**American Petroleum Institute's Review of EPA's Pavillion  
December 8, 2011 Draft Report With Focus On Monitoring Well  
Drilling, Completion, Development, And Sampling Activities  
Related To Deep Monitoring Wells MW-01 And MW-02**

JUNE 25, 2013

Prepared by: The American Petroleum Institute | 1220 L Street, NW | Washington, DC 20005-4070 | [www.api.org](http://www.api.org)

**Figure 2. Graph of pH and specific conductance readings taken during low-flow sampling of MW-01 by EPA during Phase III (October 6, 2010).**

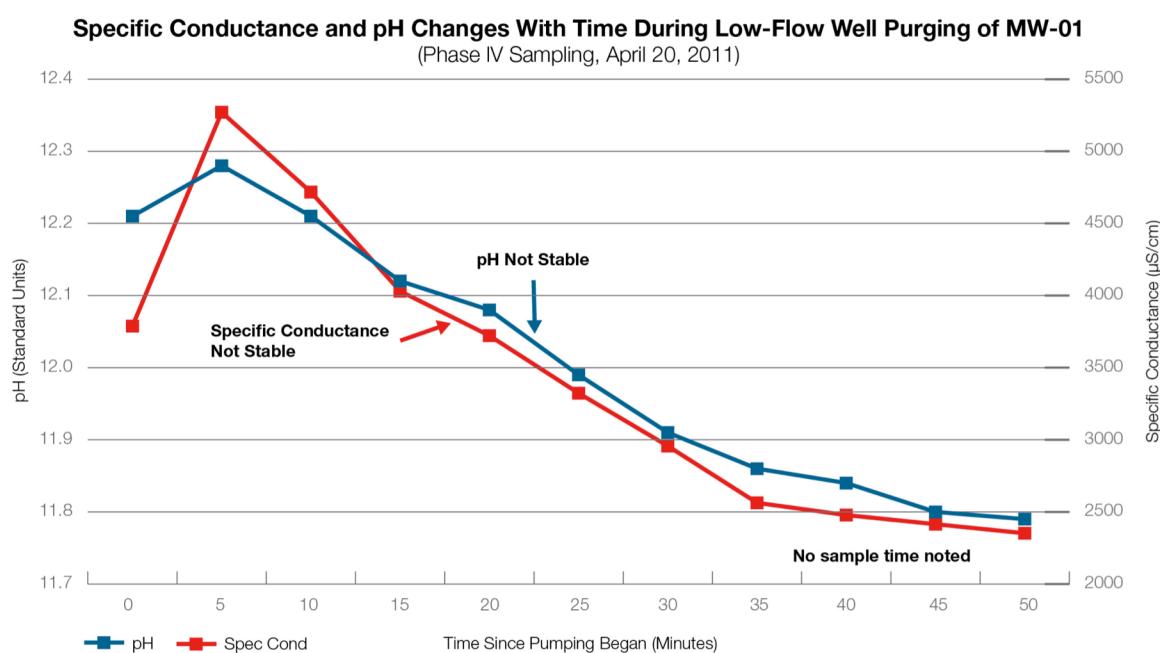
Data provided in **Tables 2** and **3** clearly and concisely show that the pH, oxidation-reduction potential, and specific conductance were not stable in well MW-01 during either of the Phase III or Phase IV sampling events, contrary to EPA's statement noted earlier on page 20 of their Draft Report<sup>1</sup>. **Figures 2** and **3** are plots of the pH and the specific conductance data from MW-01 during these Phase III and IV sampling events, respectively, and show the pH and specific conductance instability.

**Figure 4. Graph of pH and specific conductance readings taken during low-flow sampling of MW-02 by EPA during Phase III (October 6, 2010).**

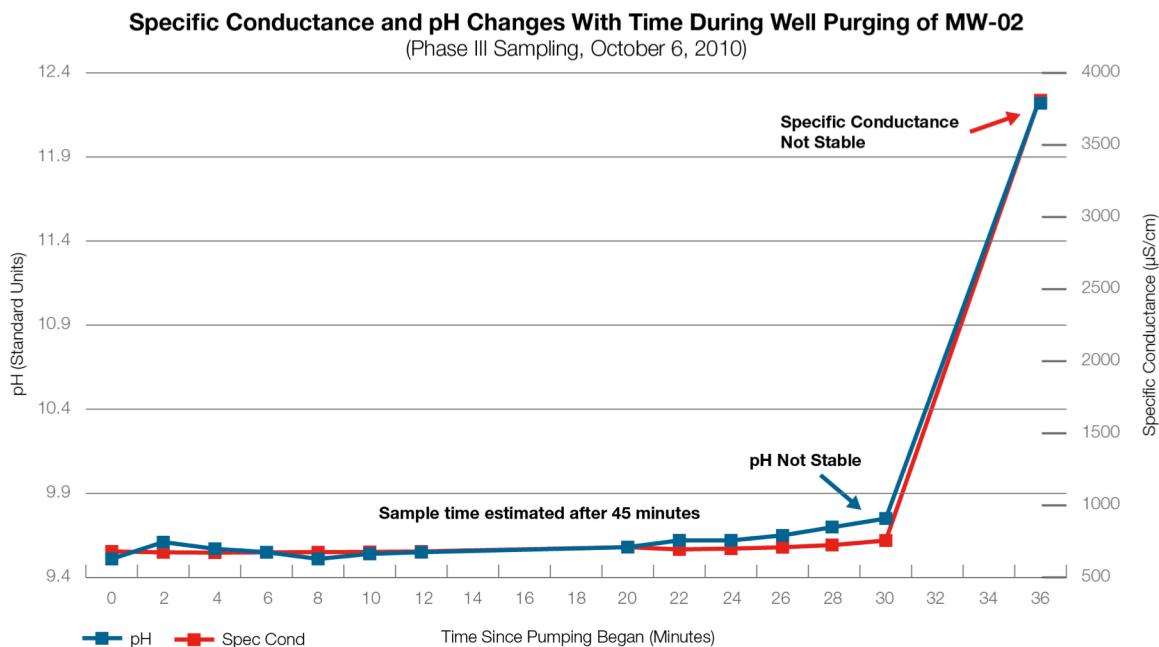
During Phase III sampling of well MW-02, a major change in pH, oxidation-reduction potential, and specific conductance occurred between 30 to 36 minutes into the low-flow pumping period. EPA does not point out this change or discuss possible reasons for the dramatic increase in pH and specific conductance (decrease in oxidation-reduction potential) in MW-02, consistent with cement contamination. Likewise, EPA fails to discuss or point out the lack of stability in the pH, oxidation-reduction potential, and specific conductance during sampling of MW-01 during both Phase III and Phase IV sampling events. The low pH between 9.3 to 9.8 and low specific conductance in monitoring well MW-02 may be due to imported water added and left in the monitoring well during development on September 11, 2010.

**Figure 5. Graphs of oxidation-reduction potential from low-flow sampling data from monitoring wells MW-01 and MW-02 during the Phase III and IV sampling events.**

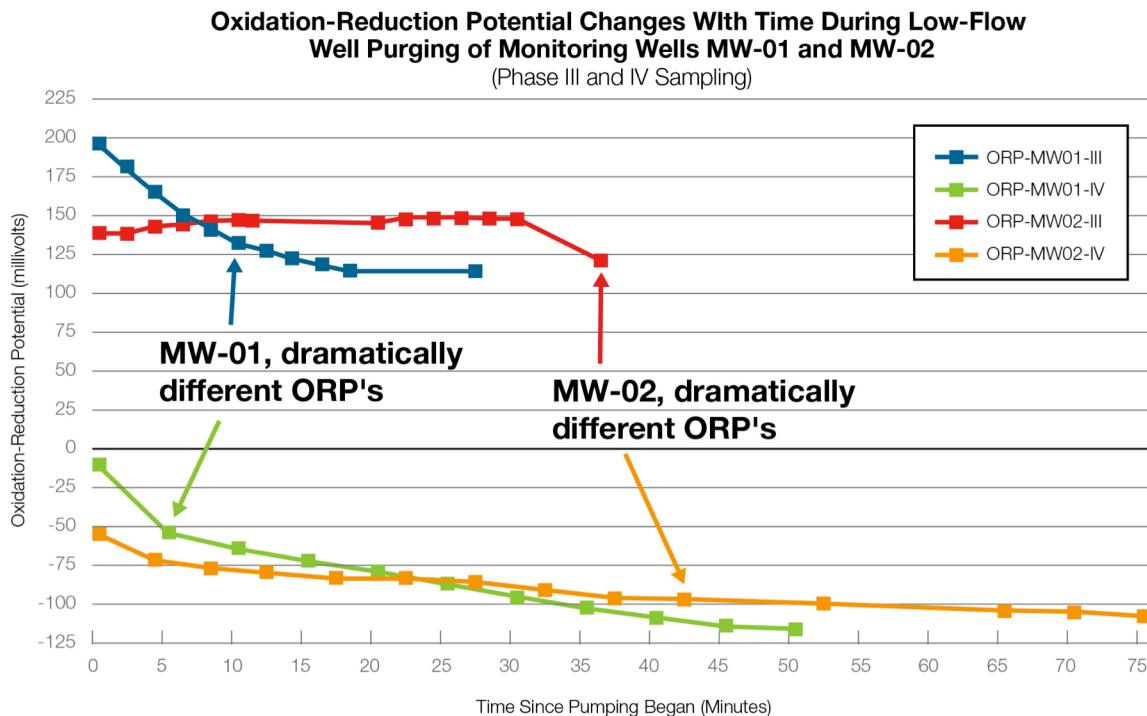
**Figure 5** is a graph of the oxidation-reduction potential (ORP) measured in groundwater from monitoring wells MW-01 and MW-02 during the Phase III and IV sampling events. These graphs also show that the ORP was unstable during the low-flow sampling events. **Figure 5** also shows that there is a large discrepancy between the ORP measured in each well between the Phase III and Phase IV sampling events. For example, the ORP measured in monitoring well MW-01 during the Phase III sampling event on October 6, 2010 ranged from 114.3 millivolts (mV) to 196.4 mV. During the Phase IV (April 20, 2011) sampling event, the ORP in this same monitoring well ranged from -10.2 mV to -116.2 mV. A similar discrepancy occurs in the ORP reading from monitoring well MW-02. EPA fails to discuss how such a large difference in ORP readings can occur in groundwater from the same well.

MW-01

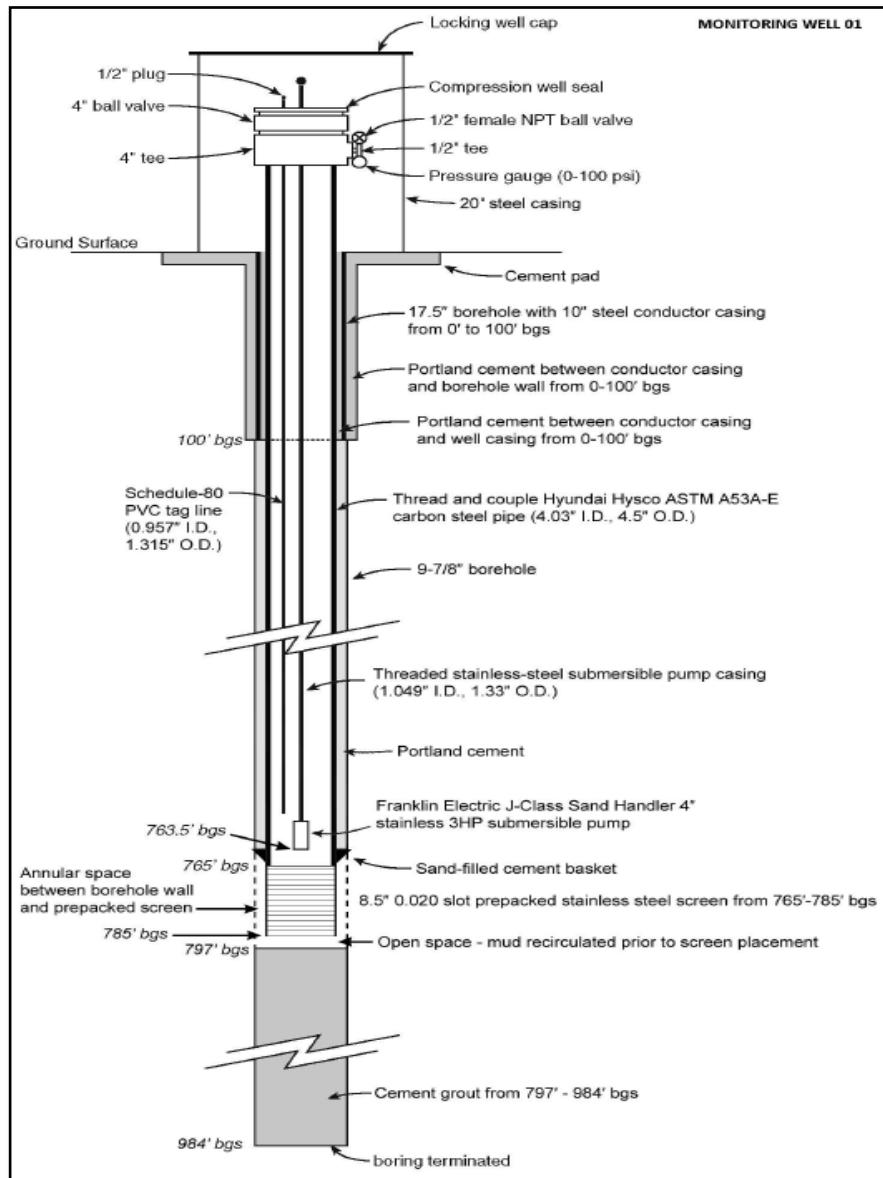
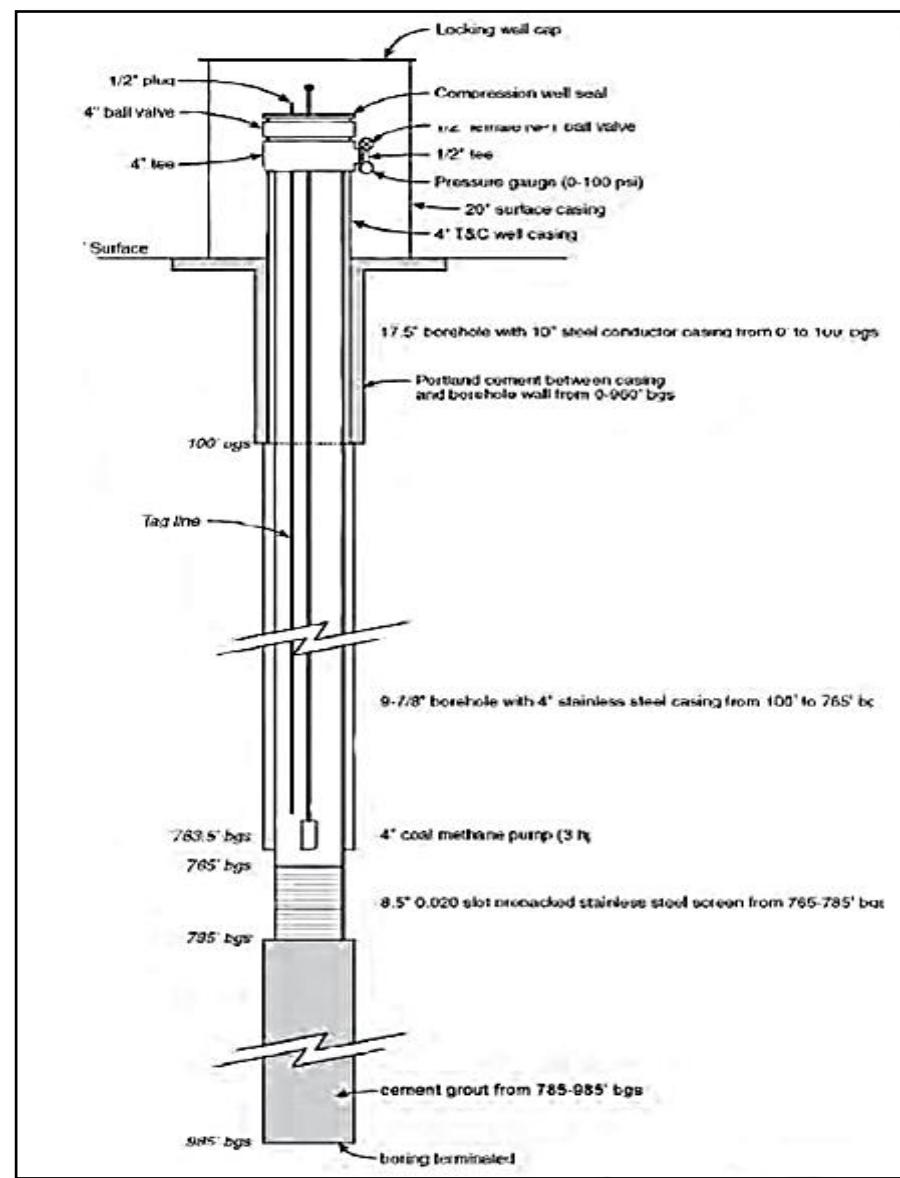
EPA's on-site contract geologist reported that the top of the cement grout used as backfill below the well screen in MW-01 was at 797 feet bgl. This is in disagreement with the 785 feet bgl reported on figure 6a of EPA's December 2011 Draft Pavillion Report<sup>1</sup>, a difference of 12 feet. In addition, the interval from 785 bgl (bottom of screen) and the top of the cement grout at 797 feet bgl as reported by EPA's on-site contract geologist was open and not filled with anything but drilling fluids/mud. This cement can also leach associated chemicals into the well screen interval.

On figure 6a, this interval (785 to 797 feet bgl) is inaccurately and incorrectly shown by EPA as being filled with cement grout. The fact that nothing was present other than drilling fluids in the borehole interval from 785 feet bgl to 797 feet bgl in MW-01 would increase the possibility of cement grout invading this open-hole interval and the well screen interval directly above. It would be virtually impossible to fully remove the drilling fluids left in this open interval through well development. Therefore, these fluids are almost certainly in contact with the well screen in well MW-01, along with cement.

Examination of the photographs provided in EPA's December 2011 Draft Pavillion Report<sup>1</sup> and **Figure 1** show the sand basket painted blue, approximately 1.8 feet long, possibly rubber/plastic lined, and welded to the top of the stainless steel well screen. A painted sand basket is not shown on figure 6a of EPA's Draft Report<sup>1</sup>.

EPA's on-site contract geologist well construction diagram<sup>18</sup> shows centralizers were used at two locations on the riser pipe in MW-01 (none are being shown as used in MW-02), but no depths are provided. The centralizers are not reported or shown on figure 6a, (or on the November 6, 2012 revised well construction diagrams for MW-01) nor are they discussed in the field notes maintained by the on-site geologist or the driller, and their use is not described in EPA's December 2011 Draft Pavillion Report<sup>1</sup>.

The well construction diagram (figure 6a) for MW-01 provided in the December 2011 Draft Pavillion Report<sup>1</sup> incorrectly indicates nothing but open space in the annular space between the 10-inch steel conductor surface casing set to 100 feet bgl and the 4-inch carbon steel casing, however, on the November 6, 2012 revised well construction diagram<sup>13</sup>, this annular interval is shown to be filled with Portland cement. The new well construction diagram<sup>13</sup> for well MW-01 posted by EPA on November 6, 2012 also correctly shows that there is an open annular space between the borehole wall (9-7/8 inches) and the 20-foot long 8.5-inch pre-packed well screen, an open annular space of approximately 1-3/8 inches which, if evenly distributed, would surround the pre-packed well screen and borehole wall filled with nothing but fluids over this 20-foot interval. The fact that nothing was present other than fluids in this 20-foot borehole interval from 765 feet bgl to 785 feet bgl in MW-01 increases the probability that cement grout invaded this open-hole interval between the pre-packed sand pack and borehole wall. None of the

well construction diagrams for MW-01 indicate that powdered bentonite was added to the cement as required by the Work Plan<sup>5</sup>, but rather, all construction diagrams for MW-01 indicate “***Portland cement***” was used.

Many of the inaccuracies and discrepancies highlighted above have been corrected on the newly posted (November 6, 2012) well construction diagram<sup>13</sup> for MW-01 on EPA’s Pavillion website<sup>12</sup>. However, the new diagram<sup>13</sup> still does not show or disclose that painted/coated carbon steel casing or riser pipe (as first reported by USGS) and a painted sand basket (with some sort of black liner) was used down hole. Finally, it is very unlikely that previous peer reviewers are aware of these significant changes.

## MW-02

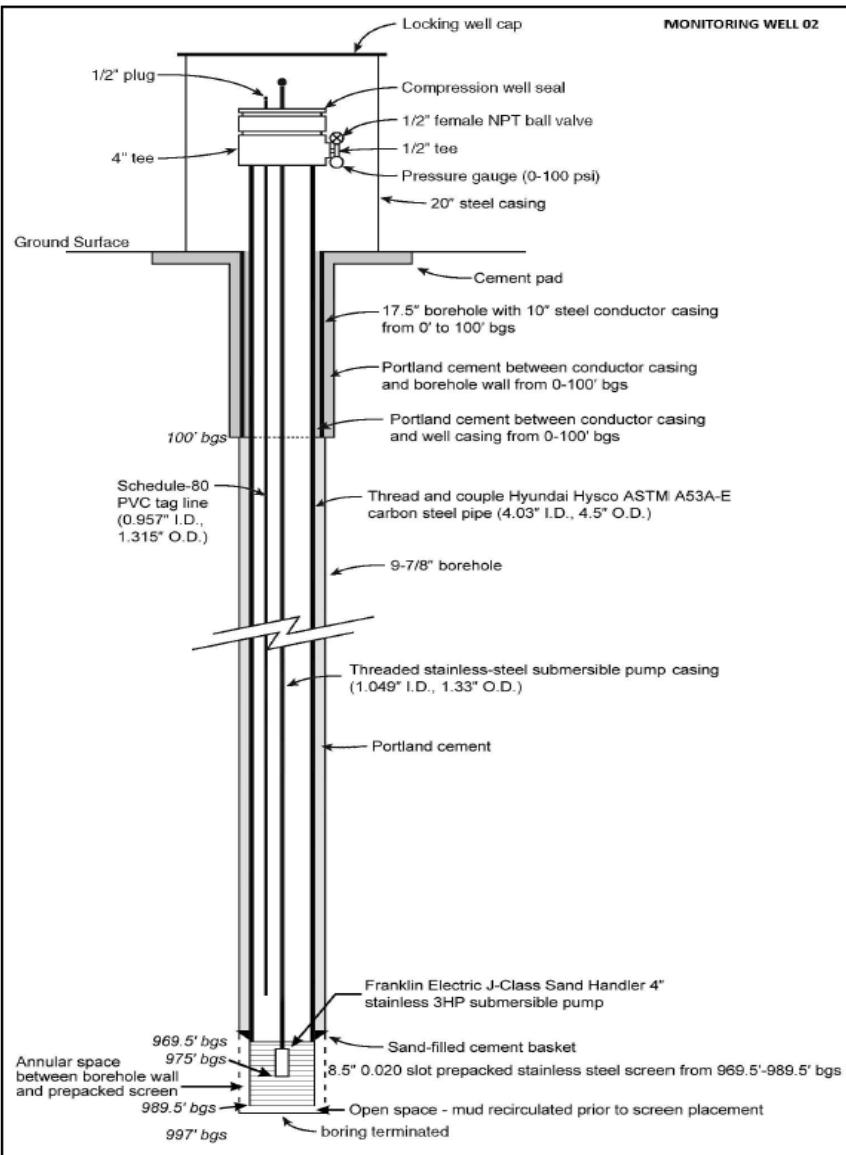
Monitoring well MW-02 construction diagram provided in the Draft Report<sup>1</sup> (besides EPA’s similar incorrect statements regarding use of the stainless-steel riser pipe versus what was actually used black painted/coated carbon steel), does not show the 1.8 foot long blue-painted (possibly black rubber or plastic lined) sand basket welded to the top of the well screen. No centralizers are shown on the on-site geologist field construction diagram<sup>19</sup> on figure 6b, or on the newly-revised (November 6, 2012) well construction diagram<sup>14</sup>. The well construction drawing (figure 6b) for MW-02 in the December 2011 Draft Pavillion Report<sup>1</sup> incorrectly indicates nothing but open space in the annular space between the 10-inch steel conductor surface casing set to 100 feet bgl and the 4-inch carbon steel casing. However, on the November 6, 2012 revised well construction diagram<sup>14</sup>, this annular interval is shown filled with Portland cement. None of the well construction diagrams for MW-02 indicate that powdered bentonite was added to the cement as required by the Work Plan<sup>5</sup>, but rather, all construction diagrams for MW-02 indicate only “***Portland cement***” was used.

There also appears to be a discrepancy in the screen placement interval. The on-site field geologist construction diagram<sup>19</sup> shows the depth of screen placement to be 960 to 980 feet bgl as does the well construction diagram provided as figure 6b in EPA’s December 2011 Draft Pavillion Report<sup>1</sup>. However, additional work conducted by USGS in 2012 reported a discrepancy in this well’s depth during down hole camera work. The revised well construction diagram<sup>14</sup> for MW-02 posted on EPA’s Pavillion website<sup>12</sup> on November 6, 2012 show that the screen intervals has been revised downward by 9.5 feet, or the screen is now reported to occur from 969.5 feet bgl to 989.5 feet bgl. Open hole exists below the screen (screen bottom at 989.5 feet bgl) to 997 feet bgl (a distance of 7.5 feet) where the hole may be filled with drilling mud and/or cuttings.

The well construction diagram, for MW-02 provided in the December 2011 Draft Pavillion Report<sup>1</sup> and the on-site field geologist field diagram<sup>19</sup> reports the open hole interval below the screen to be filled with “***cuttings and mud fill***” materials, but the newly revised November 6, 2012 diagram<sup>14</sup> inexplicably states that that this material is now “***mud recirculated prior to screen placement.***” It would be virtually impossible to fully remove the drilling fluids left in this open interval through well development. Therefore, these fluids are almost certainly in contact with the well screen in well MW-01, along with cement.

Many of the inaccuracies and discrepancies highlighted above have been corrected on the newly posted (November 6, 2012) well construction diagram<sup>14</sup> for MW-02 on EPA’s Pavillion website<sup>12</sup>. However, the new diagram<sup>14</sup> still does not show or disclose that painted/coated carbon steel casing (as first reported by USGS) and a painted sand
